NCUTCD Bicycle Technical Committee Minutes

Wednesday, June 26, 2013, Portland, Maine

Prepared by John S. Allen, September 6, 2013

Bike merge area (per NACTO UBDG 2nd ed.)

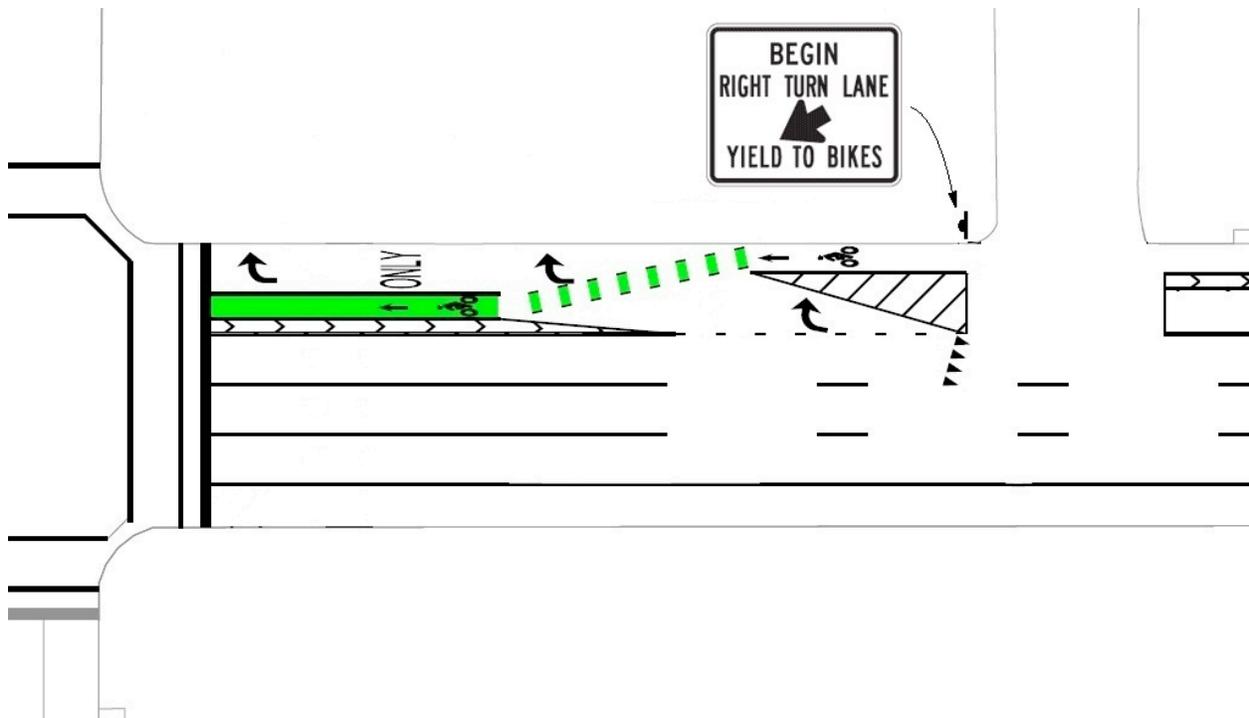
Dunn brought up a mixing zone design with a yield bar. This is depicted in the second edition of the NACTO Urban Bikeway Design Guide - people see things like this in the NACTO guide and think that it must be approved for general use. This is one example.

Ciccarelli: This design works well at low speeds, in practice. There is a floating parking lane.

Schubert: The yield sign is not where motorist will see it.

Allen: Because of the parked cars and the cycle track to its right, signs at the right side of the street have to be placed very high on posts to be visible to motorists.

Petritsch: This is not a merge, it is a double crossing. The rear end of the vehicle yielding to bicyclists is still sticking out into the through lane, though this occurs in many other places.

Dunn: It violates the manual. We can't do that. A yield sign must apply to all lanes.

Curtis: The yield sign for one lane works in some situations. Document them?

DeRobertis: What about upstream conditions?

Stafford: Why not a shared-lane marking?

Van Houten: In-street signs?

Schultheiss: Low speed is important. People leap to the assumption that the design is for 45-50 mph. He is disturbed by motorists' stopping to yield to cyclists when cyclists should be yielding. Which is worse?

Ciccarelli: This is a preview of what we address with all nuances of cycle tracks. New York didn't care about being MUTCD compliant. Design a sign to place at curbside? Volume, gap acceptance are issues.

Proposed revised bike merge area - with R4-4 and yield line in travel lane
